**LINCOLN PARK PLANNING COMMISSION**  
CITY HALL – COUNCIL CHAMBERS 1355 SOUTHFIELD ROAD  
LINCOLN PARK, MICHIGAN

2041 Fort Street – Medical Clinic

## Site Plan Review

Applicant	Aminatou Salam-Edu
Project	Medical Clinic
Address	2041 Fort Street, Lincoln Park, MI 48146
Date	November 14, 2018
Request	Site Plan Review
Recommendation	Approve with conditions

SITE PLAN

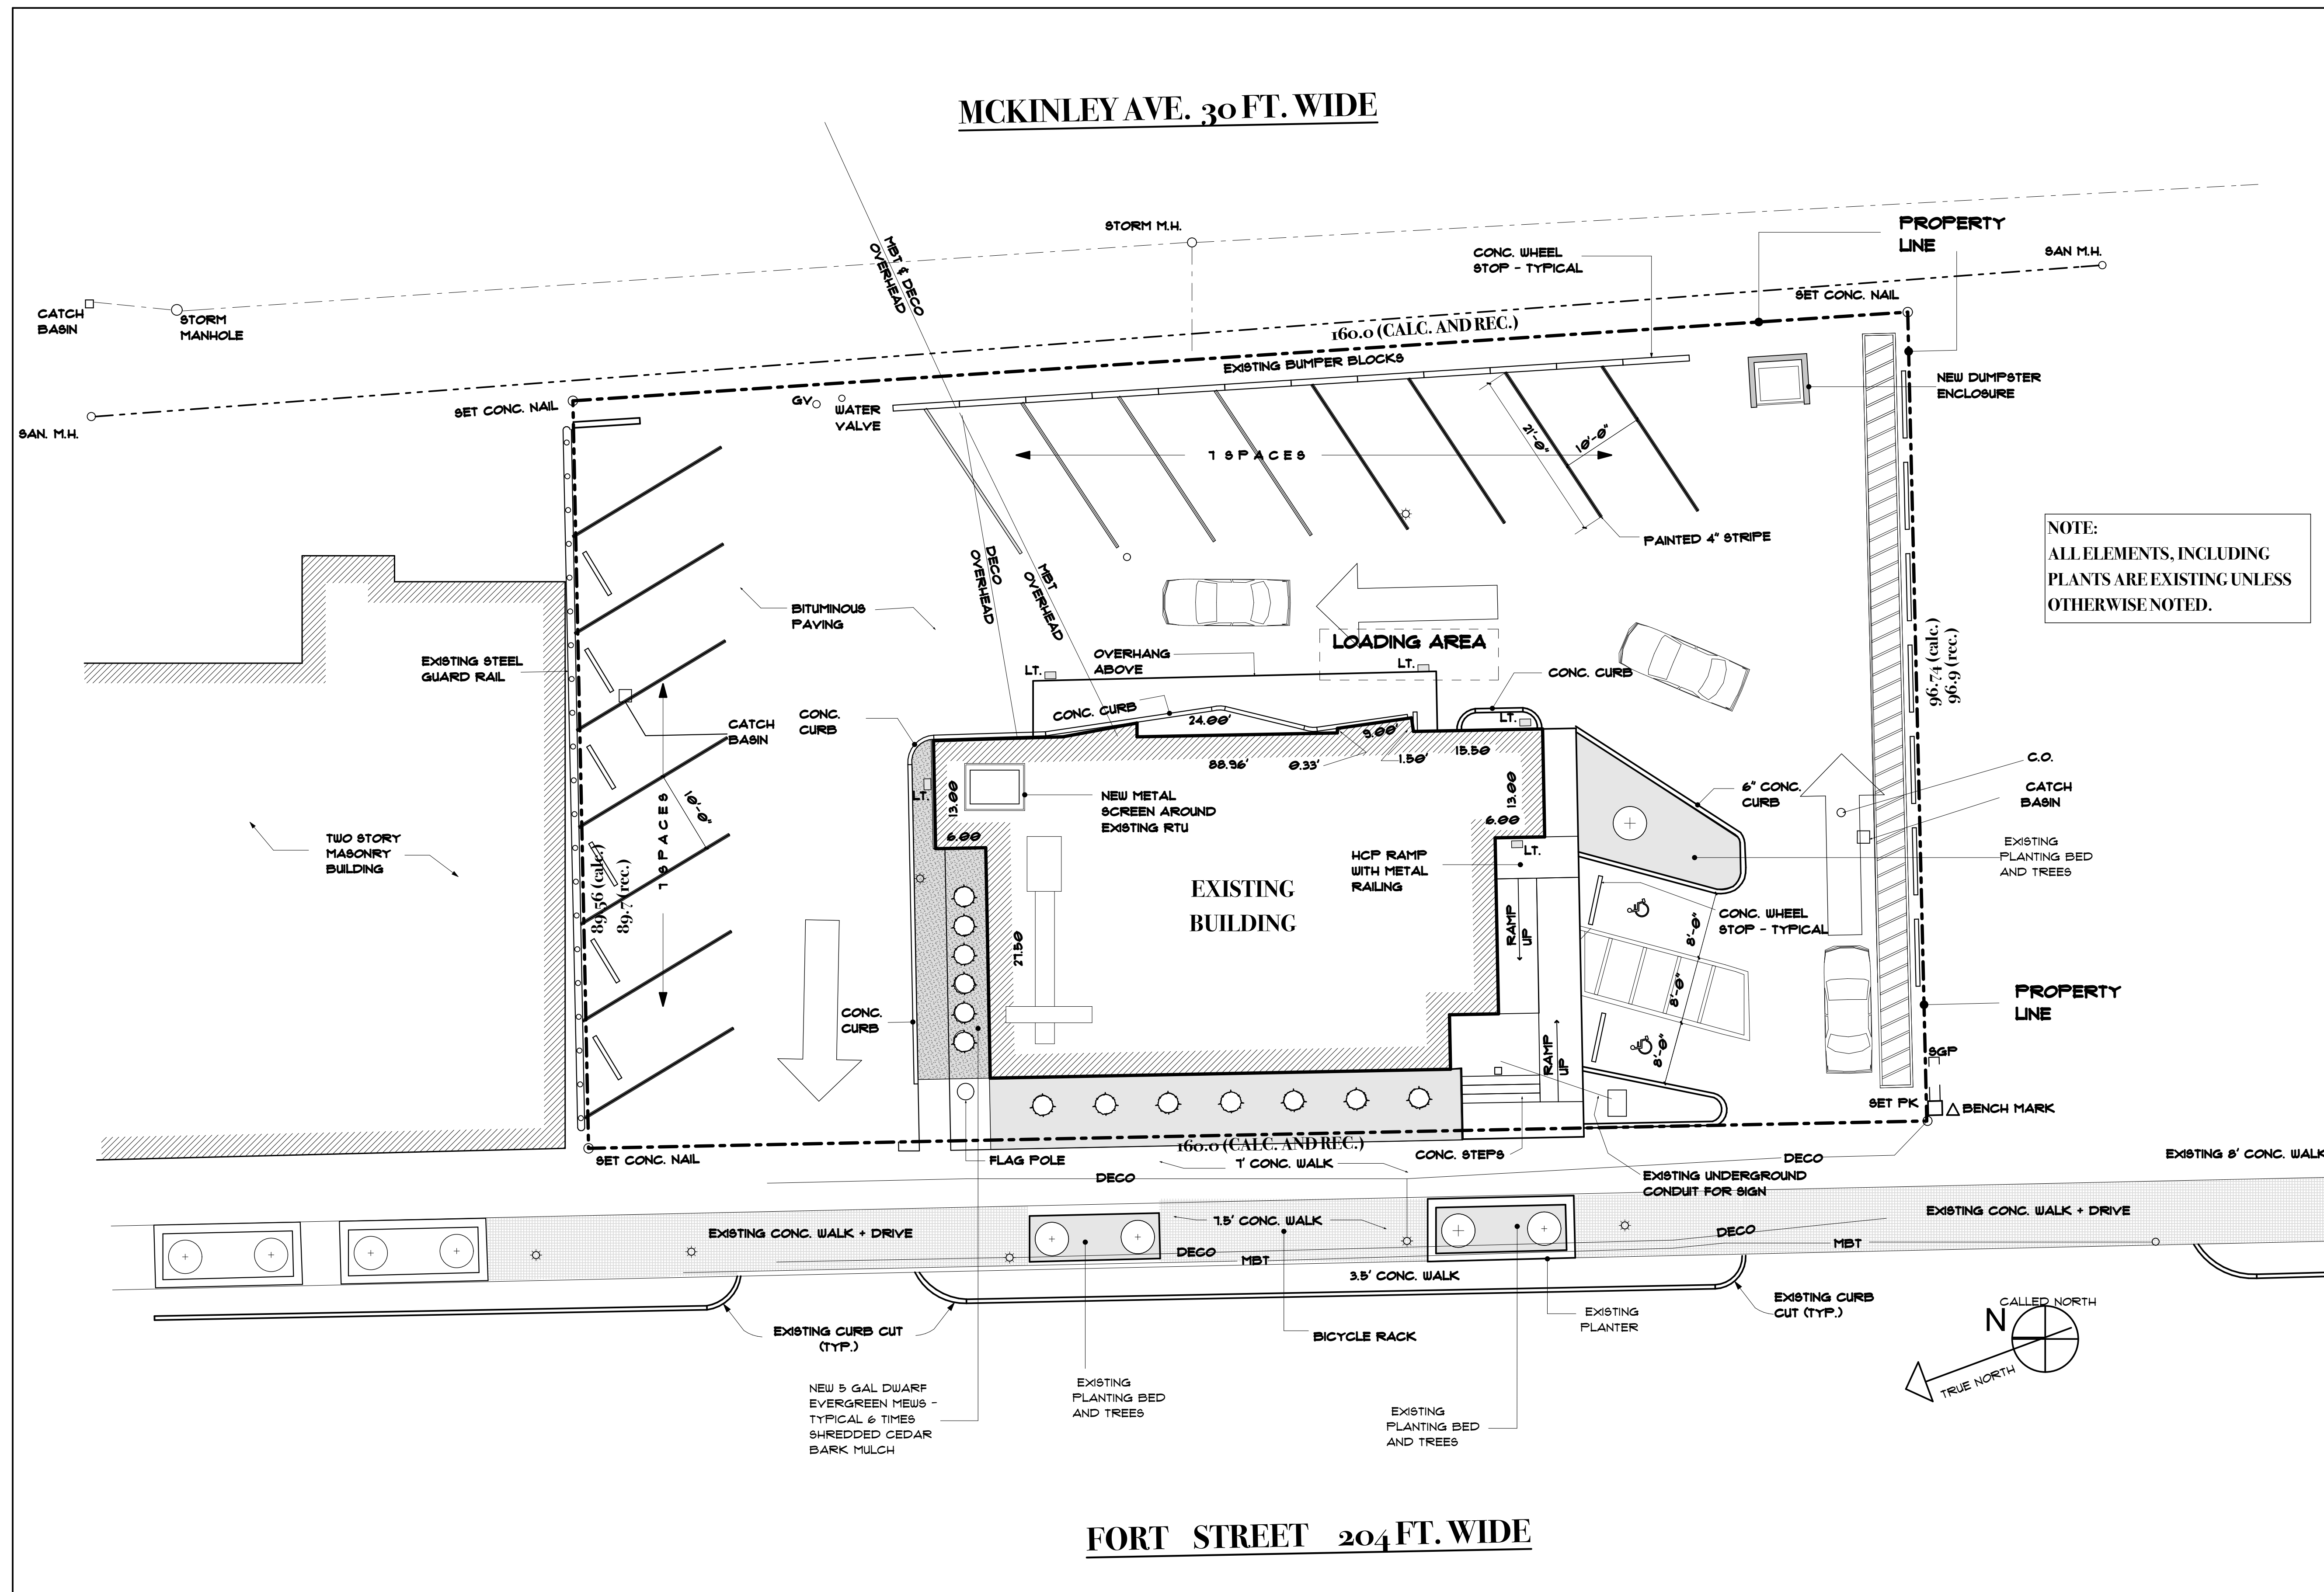
- Concrete sidewalks must be brought up to City Standards; any broken, cracked or unsafe sidewalks in the Fort Street right of way and onsite should be repaired.*
- Pedestrian circulation system, designated by textured pavement, shall be shown on site plan.*

- Curb size and radii shall be indicated on the site plan.*
- The site plan shall indicate the movement on the north drive way is "Right-turn in / right-turn out only to meet the required standards.*
- All work within the Fort St. right-of-way is under the jurisdiction of MDOT; applicant to secure appropriate permits as needed*

- Species detail to be provided for all existing and proposed landscaping*
- Obscuring hedge to be provided where headlamps from vehicles parked facing McKinley St will shine into ROW*
- Interior landscaping to be increased by 160 square feet, including the provision of 1 additional tree*
- Planning commission waiver requested to accept 30% of landscaping required for new development on this redeveloping property*
- Applicant to specify material of waste receptacle screening gate and show installation detail*

SHEET TITLE  
**SITE PLAN-ENLARGED**

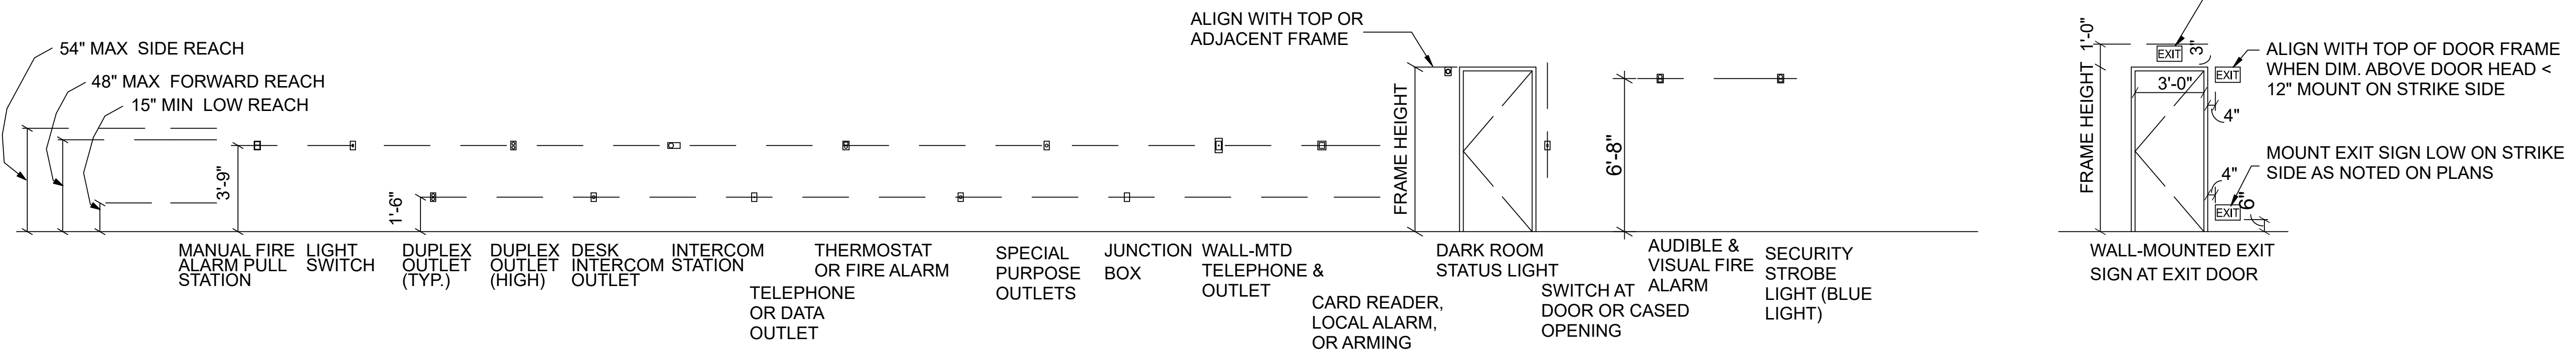
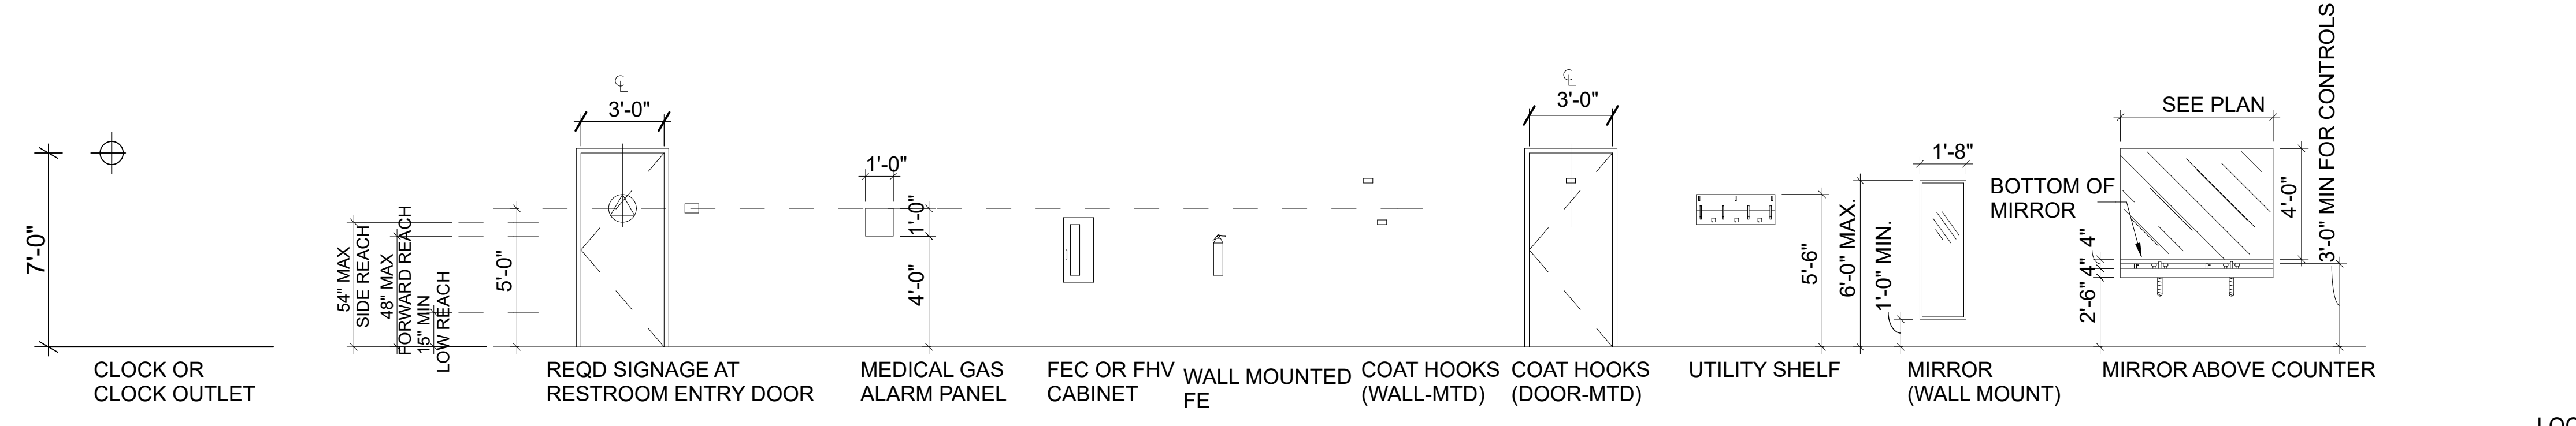
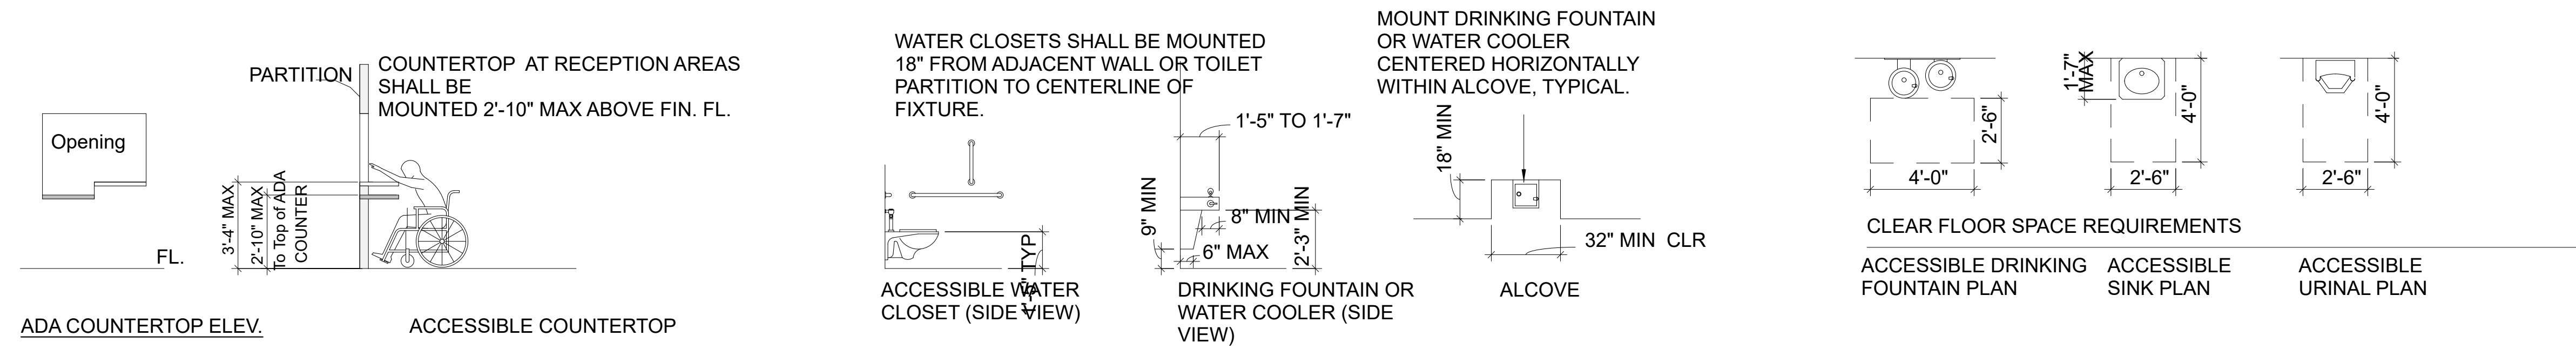
- Planning commission waiver sought to accept 15 spaces instead of 18, meeting 83% of the required parking.*
- Sheet 73 Site Plan Enlarged, indicates seven (7) parking spaces on the north, while the drawing shows six (6) parking spaces provided; applicant to correct label to match drawing.*
- Gutters shall be addressed on site plan and elevations.*
- Applicant to get a recommendation during Detailed Engineering from an engineer or asphalt contractor to address areas of immediate repair and to schedule a complete resurfacing of the parking lot*

- *Pedestrian circulation system, designated by textured pavement, shall be shown on site plan.*
- *Sheet 73 Site Plan Enlarged, indicates seven (7) parking spaces on the north, while the drawing shows six (6) parking spaces provided; applicant to correct label to match drawing.*
